APPEAL SUMMARY

Appeal ID: 20805

Project Address: 929 SW Salmon St

Building/Business Name: Fountain Place Apartments

Sheet Title:
PROPOSED FIRE & LIFE SAFETY
PLANS

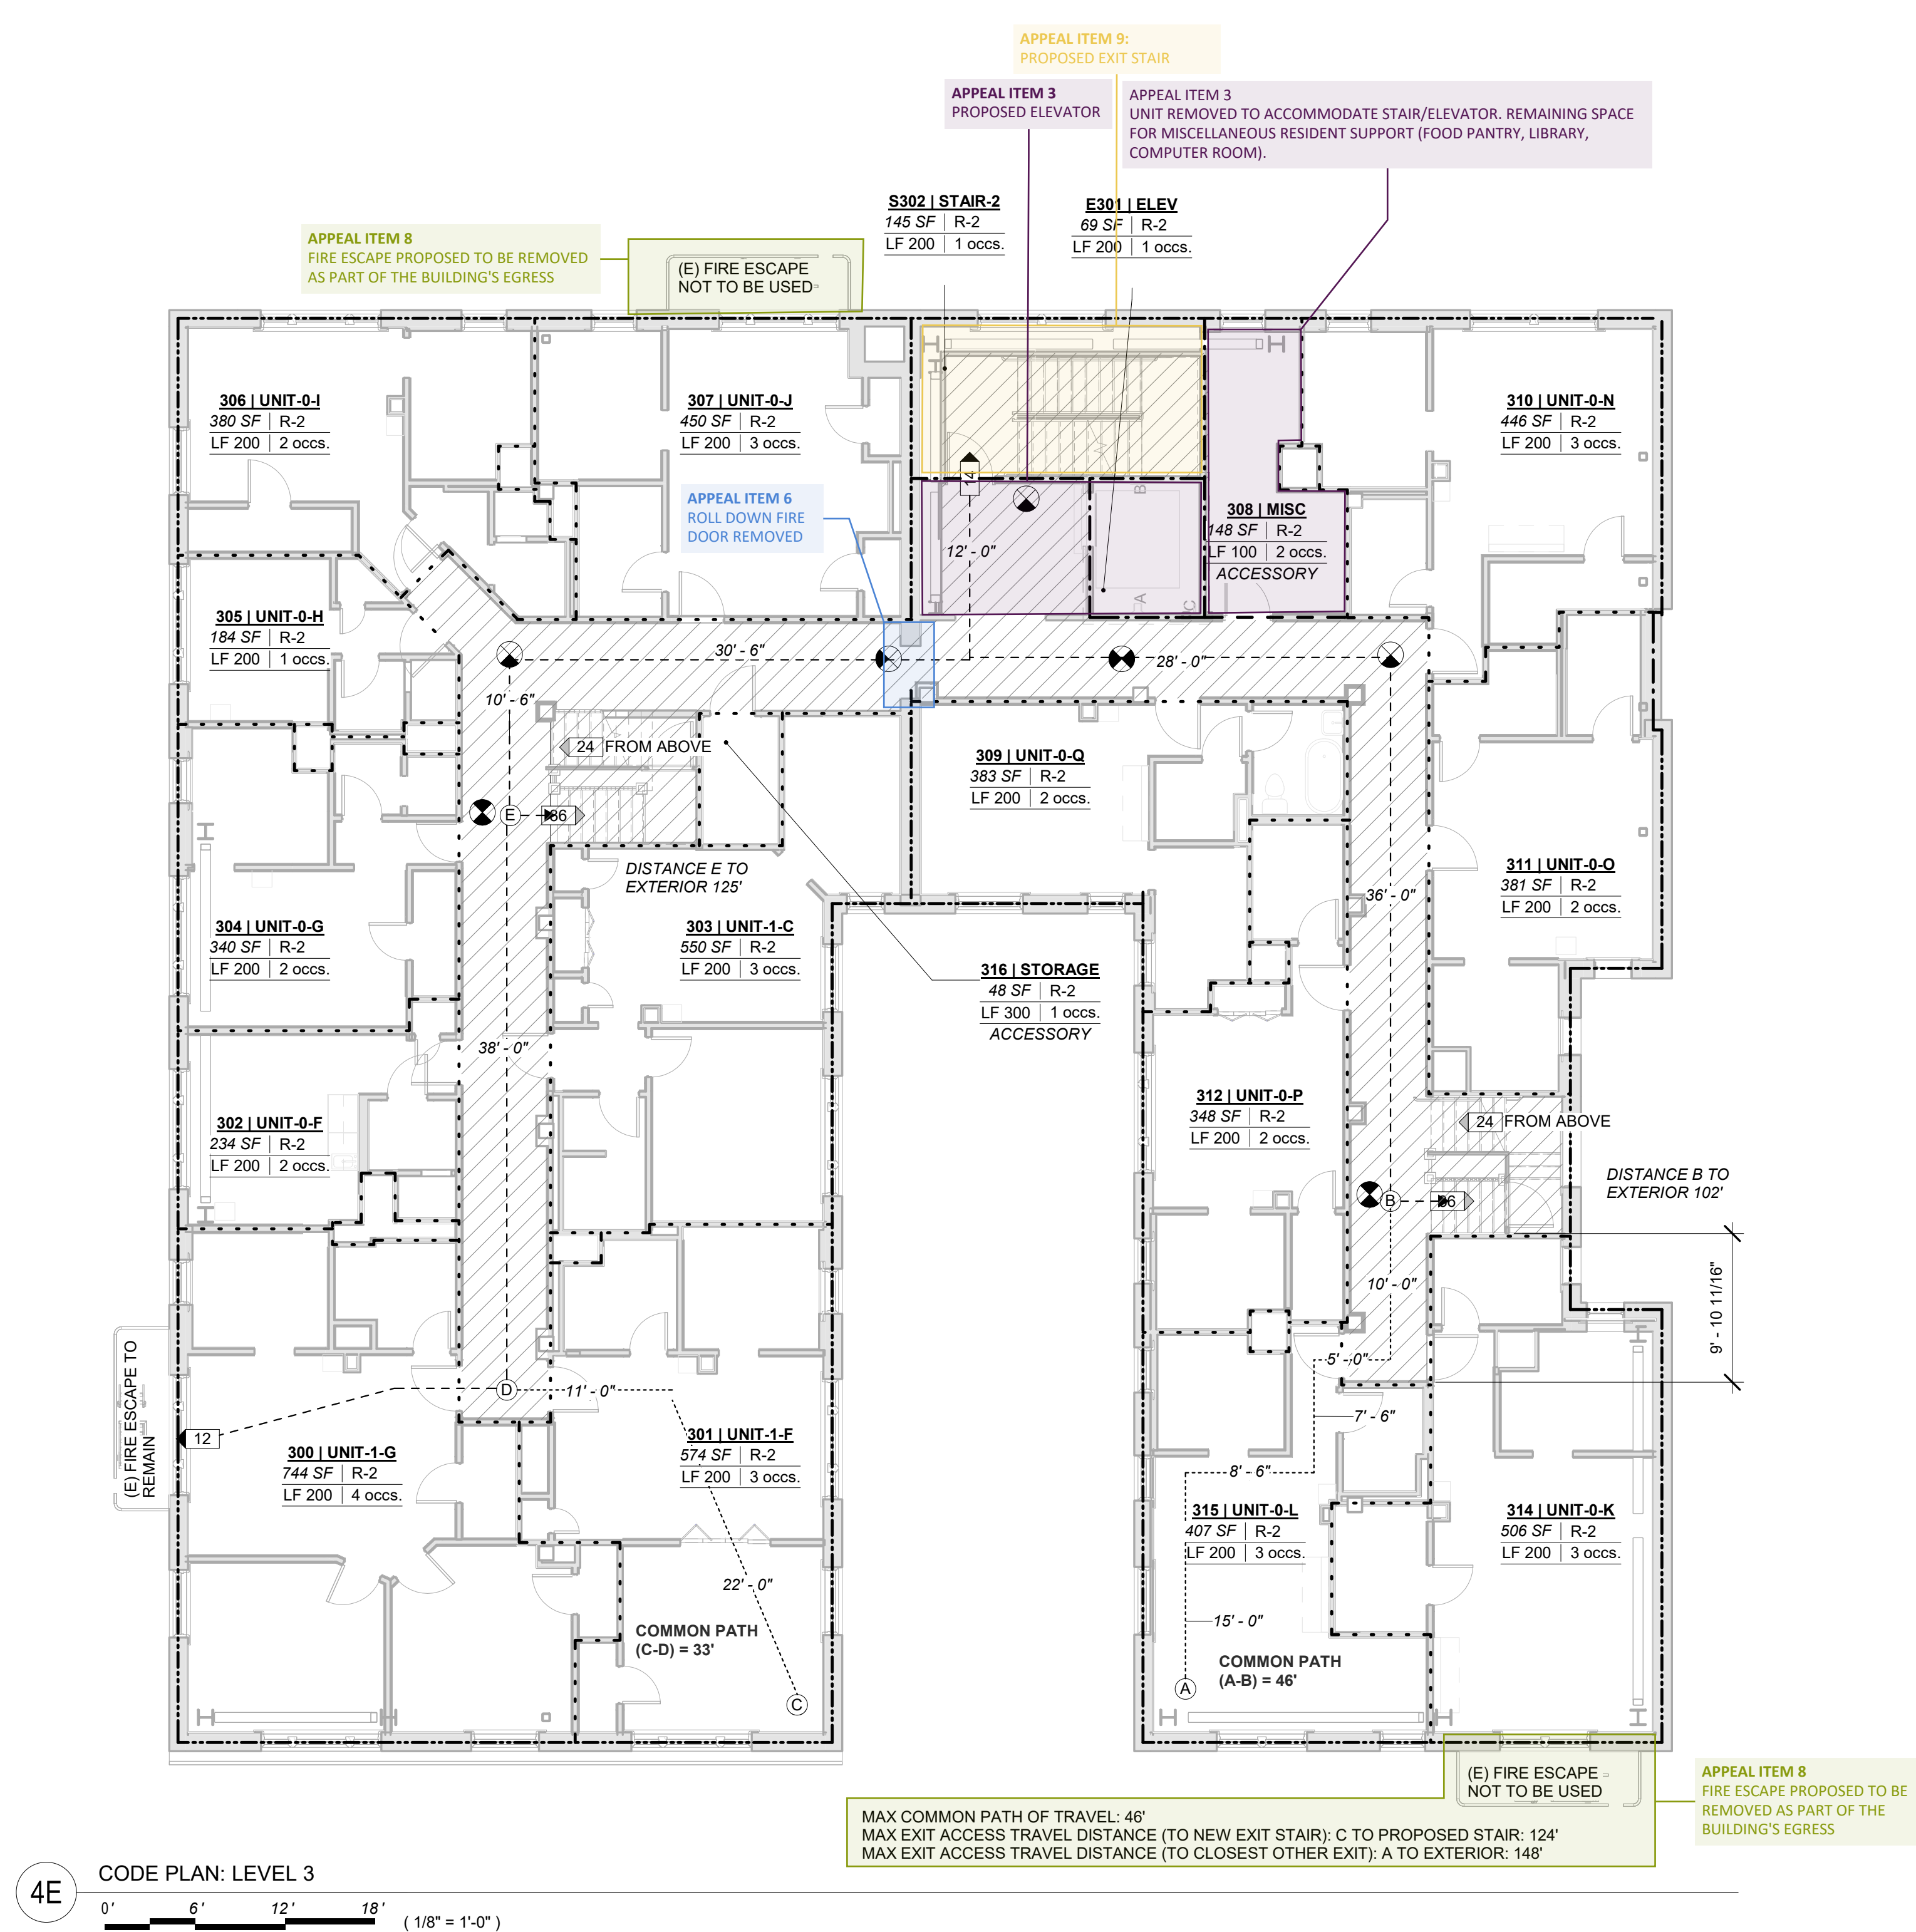
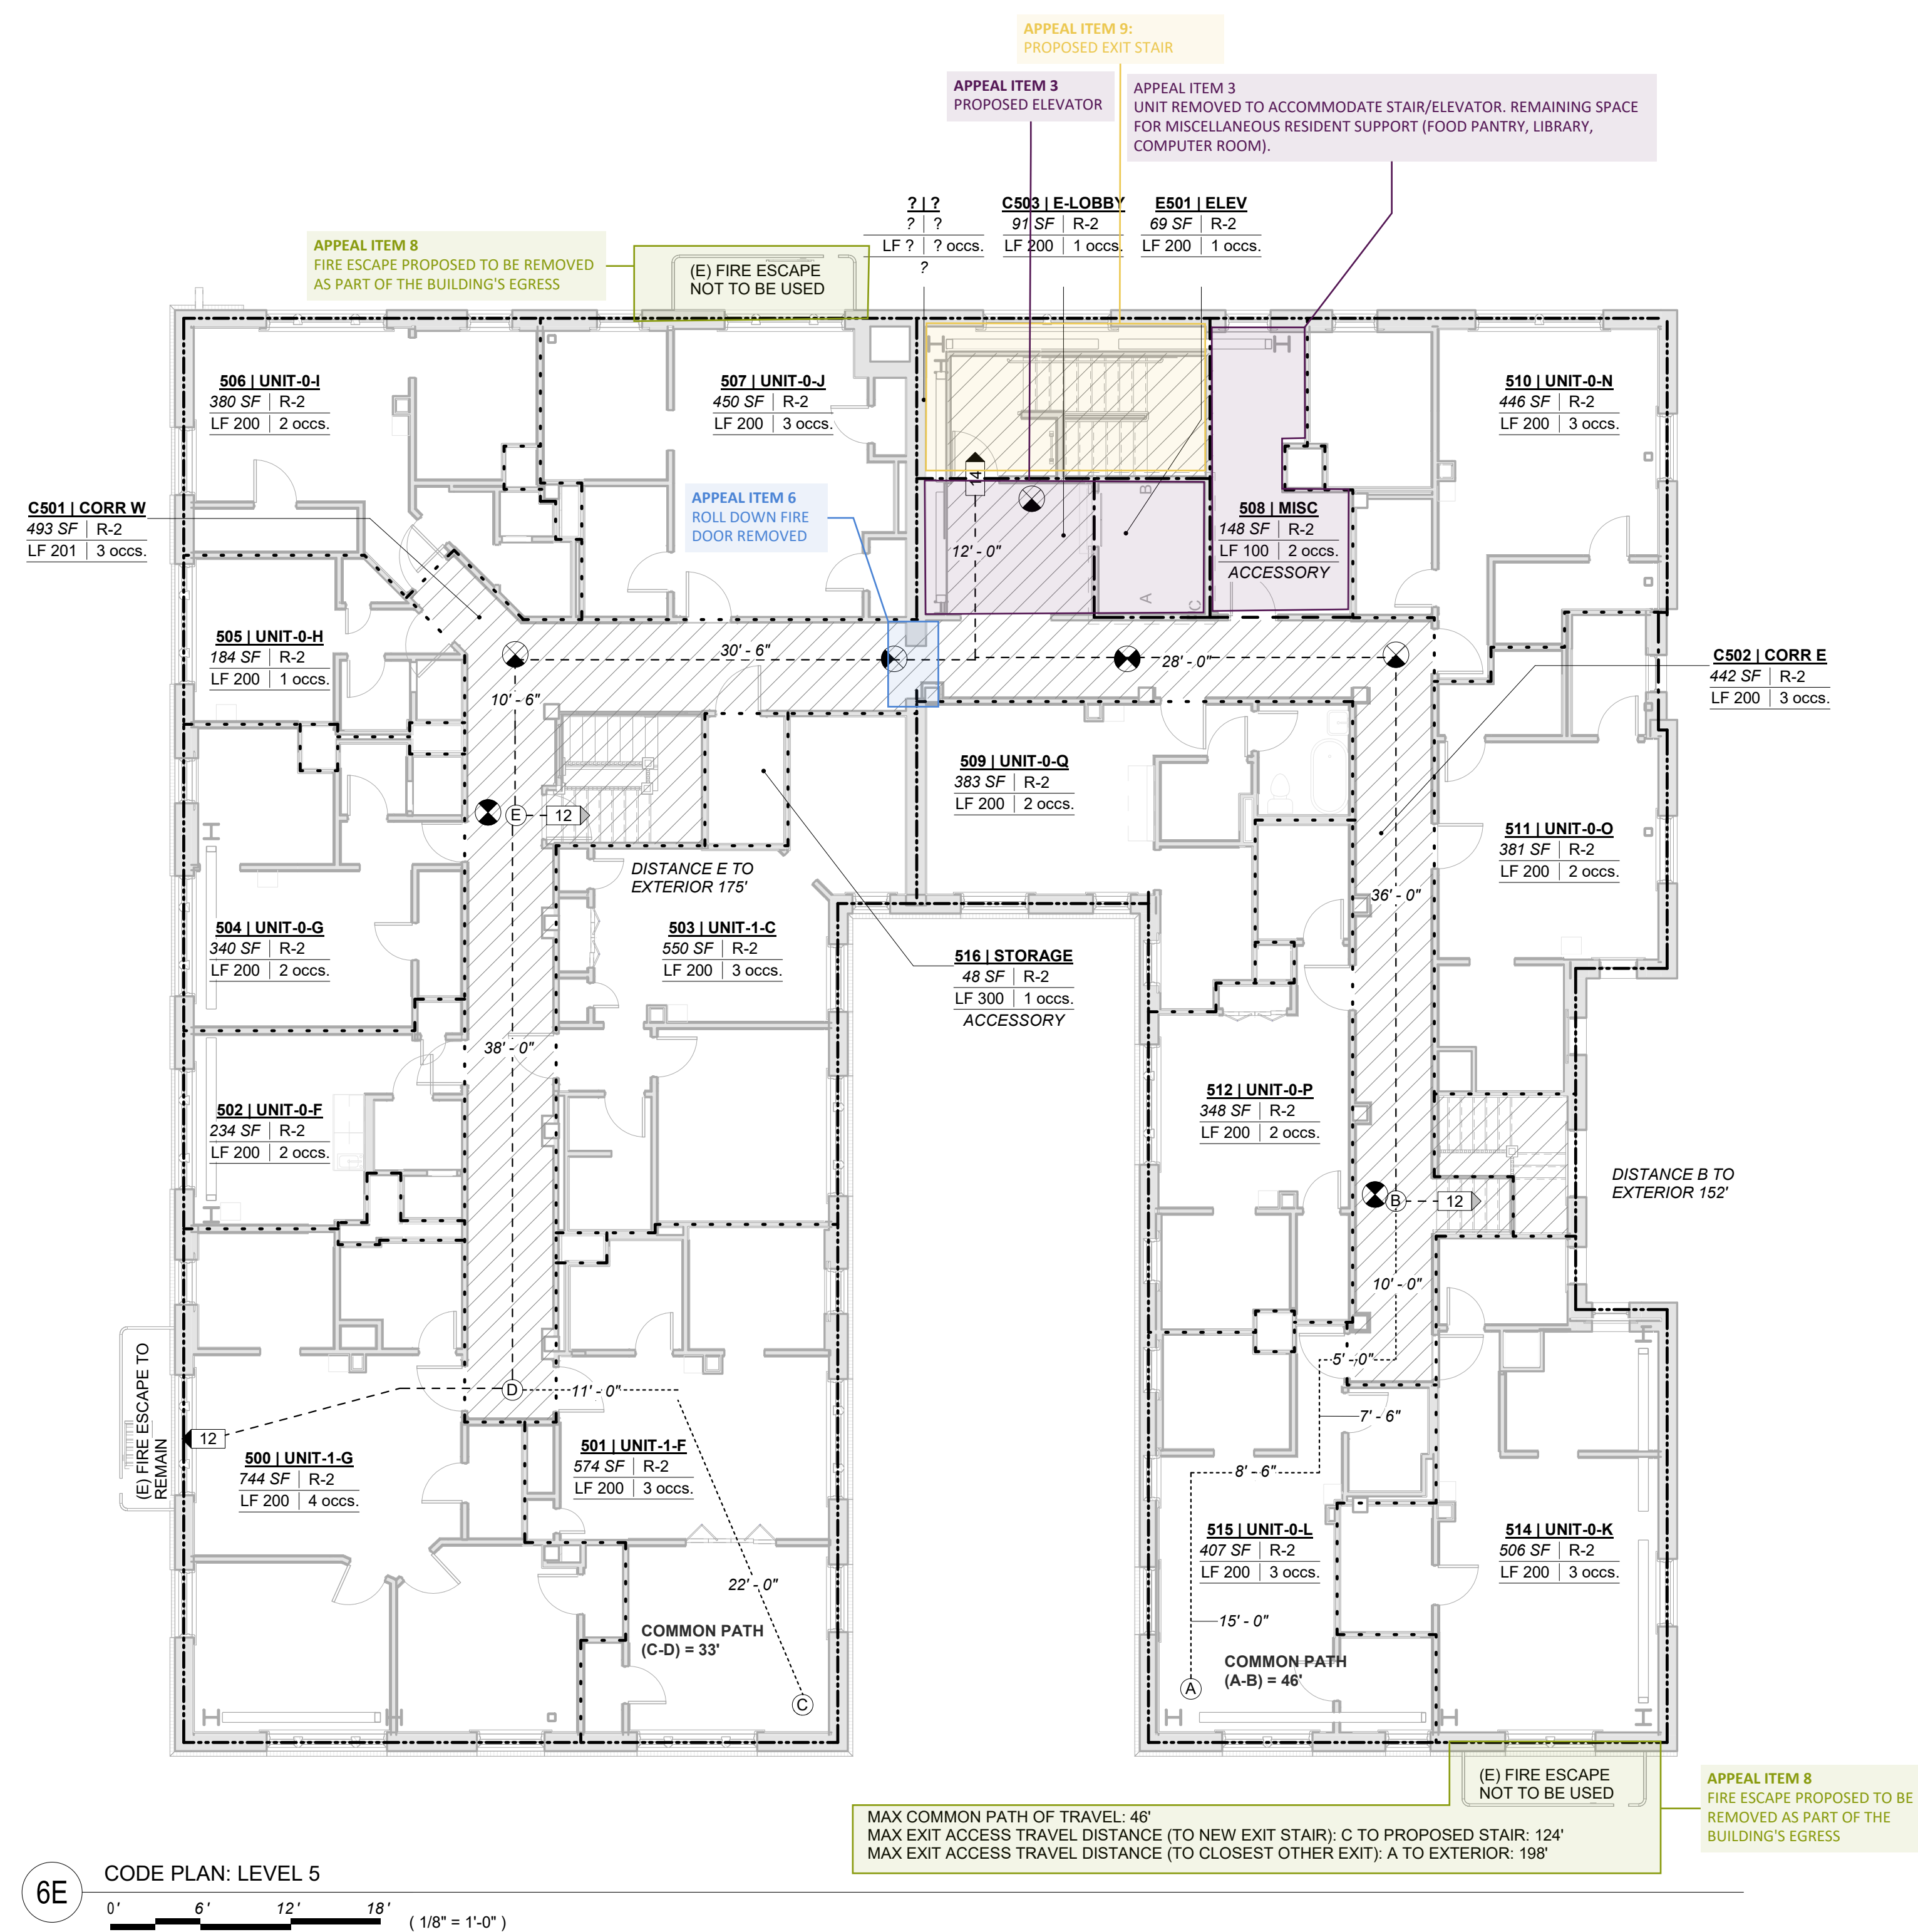
The existing building is separated into two wings by a 4-hour masonry wall. There is a single opening between the wings at each floor level. In the existing building roll-down fire doors protect the openings on Levels 2 – 5 and a self-closing door protects the opening at Level 1. There is no protection of the opening at Level 0.

In the event of a fire, the existing roll-down fire doors will prevent the west wing of the building from accessing the proposed egress stair. The proposed design is to no longer treat the masonry wall as a Fire Wall (per 706) and remove the roll-down fire doors. The proposed design will allow access to the egress stair from both wings of the building, significantly improving exiting. Reference sheets G-110/G-111 for existing conditions, and sheets G-115/G-116 for proposed.

Reason for alternative The removal of the roll-down doors will enable residents on the west wing of the building to access the new enclosed exit stairway and will improve egress for all occupants. The building meets the building area requirements per Section 503 without the Fire Wall. Section 503 notes a maximum building story area of 16,000 sf – the existing building story area including both wings is 7,600 sf, less than half the maximum prescribed per code. The total building area also falls under the threshold prescribed by Section 503 for a Type IIIB building with R-2 occupancy. Code notes a maximum area of 64,000 sqft (4 stories at 16,000 sqft per story). The total area of the existing building falls well under this threshold at 45,336 sqft. With the proposed configuration the Fire Wall is not required per code. The masonry wall is proposed to remain; however, the openings will no

4. **Increase in bottom of door clearance to finish floor: Granted as proposed.**
5. **Replacement of fire escape access doors: Granted as proposed.**
6. **Removal of roll down fire doors between East and West wings: Denied. Proposal does not provide equivalent Life Safety protection.**
